Work Order ID 92706

Item Name: Crosstube Fwd High

DART AEROSPACE LTD		Work Order:	92706
Description: Crosstube High Fwd (205/212/412)		Part Number:	D212-664-101
Inspection Dwg: D212-664-141 Rev: D		Page 1 of 1

DRAWING NO. D212-664-141	TITLE XTUBE ASSY (205/212/412 HI FWD)	REV. D	DART AEROSPACE LTD ENGINEERING ORDER		D.E.O. NO. D212-664-141-D-1	SHEET NO. SHEET 1 OF 2	SCALE NTS
DRAWN	CHECKED	MFG. APPR.	APPROVED	DE APPR.			
DATE 11.04.07	DATE 11.07.11	DATE 11.04.12	DATE 11/04/12	DATE 11.04.12

**D212-664-141/-141B
ASSEMBLY DETAIL**

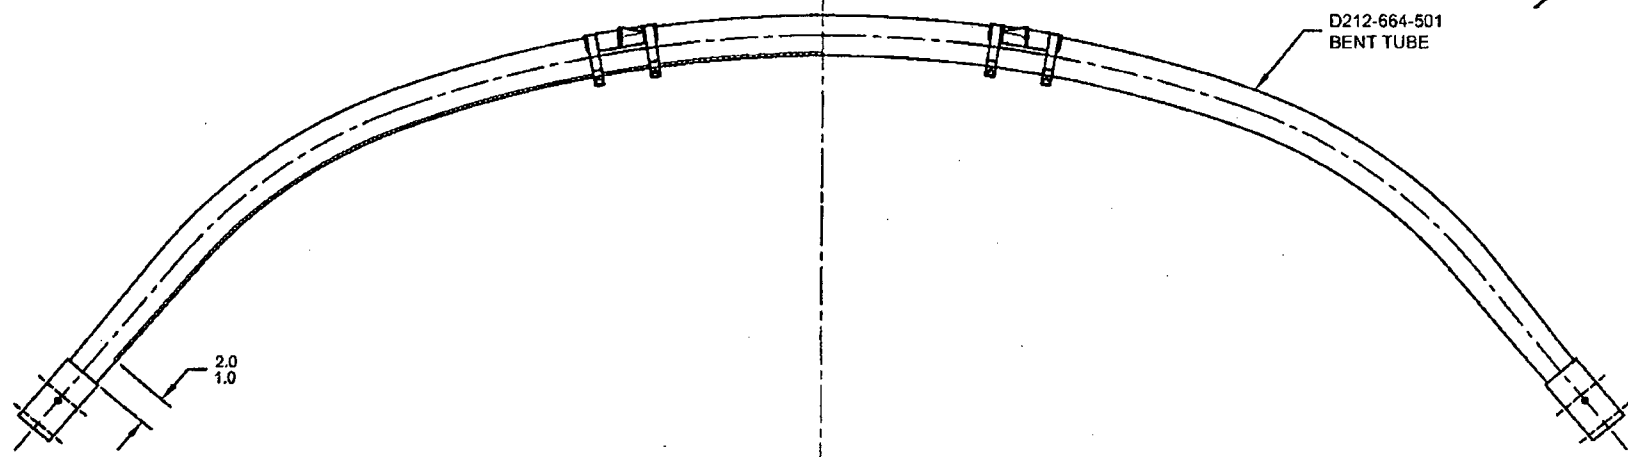
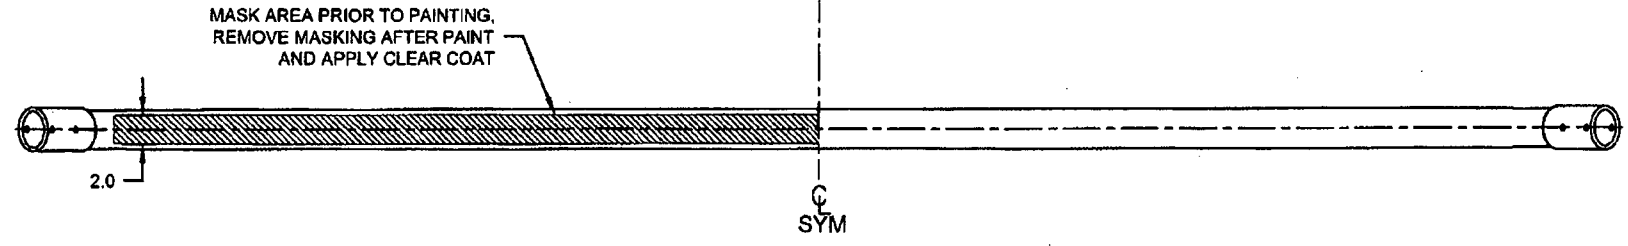
ADD AN INSPECTION WINDOW TO UNDERSIDE OF CROSSTUBE.

NOTES 2 OF SHEET 1 IS AMENDED AS FOLLOWS:

- 2) FINISH: CHEMICAL CONVERSION COAT PER DART QSI 005 4.1
PRIME INSIDE AND OUTSIDE PER DART QSI 005 4.2
MASK UNDERSIDE OF CROSSTUBE AS SHOWN (HATCHED AREA) AND
PAINT OUTSIDE PER DART QSI 005 4.2
REMOVE MASKING AND APPLY CLEAR COAT

IS:

WAS:
